UNITED STATES PATENT AND TRADEMARK OFFICE

APPLICATION NO.	FILING DATE	FIRST NAMED INVENTOR	ATTORNEY DOCKET NO.	CONFIRMATION NO.
10/799,307	03/12/2004	Jae-Hyun Kim	8054L-50 (LW9007US/HJ)	8101
22150 7590 06/09/2010 F. CHAU & ASSOCIATES, LLC 130 WOODBURY ROAD WOODBURY, NY 11797				
EXAMINER				
CHEN, LUCY P				
ART UNIT		PAPER NUMBER		
2871				
NOTIFICATION DATE		DELIVERY MODE		
06/09/2010		ELECTRONIC

Office Action Summary

DETAILED ACTION

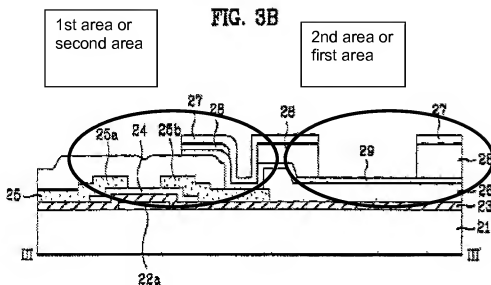
Regarding Claim 8,37.

Kim et al (Fig 3b) discloses a first substrate (21) having a first area (broad and can be interpreted to be anywhere, shown below) and a second area (shown below) a switching device (22a) formed on the first substrate (21), a first insulating layer (26) formed on the switching device; a pixel electrode (29) formed on the first insulating layer (26) and connected to the switching device (25b), a second insulating layer (28) formed on the pixel electrode (29) and in the first area, a reflecting plate (27) formed on the second insulating (28) a second substrate ([0006]) facing the first substrate (21); and a liquid crystal layer ([0006]) interposed between the first and second substrates; the

reflecting plate partially overlaps (the reflector overlaps all the transparent regions to make it a reflective region, thus, overlaps with the second area) with the second area (shown circled below,).

Kim et al does not disclose the liquid crystal molecules rubbed along a predetermined direction.

In addition to Kim et al and Ha as disclosed above, Kim et al (Fig. 3b) discloses wherein the pixel electrode (29) is electrically connected to the switching device (25b) through a contact hole that is formed through the first insulating layer (26).

In addition to Kim et al and Ha as disclosed above, Kim et al (Fig. 3b) discloses wherein a portion of the reflecting plate (27) makes contact with the pixel electrode (29) in the second area (shown above, the reflecting plate contacting the pixel electrode to contact the drain (25b)).

FIG.1

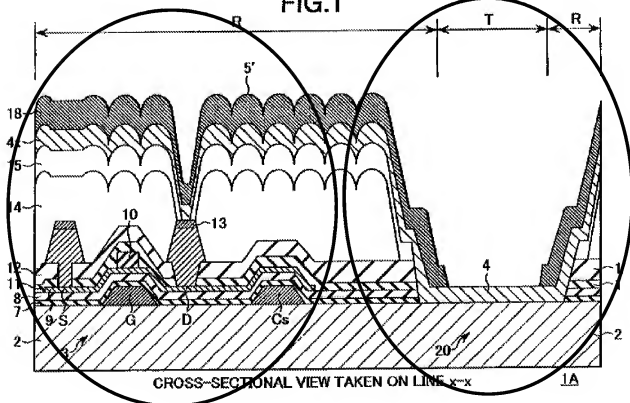
Regarding Claim 41.

Shigeno et al discloses (Fig. 1) wherein a portion of the reflecting plate is formed in the second area (T).

Shigeno et al discloses (Fig. 1) wherein a portion of the third insulating layer is formed in the second area (shown above).

Shigeno et al discloses (Fig. 1) wherein the pixel electrode (4x) is electrically connected to the switching device (13) through a contact hole that is formed through the second insulating layer (14).
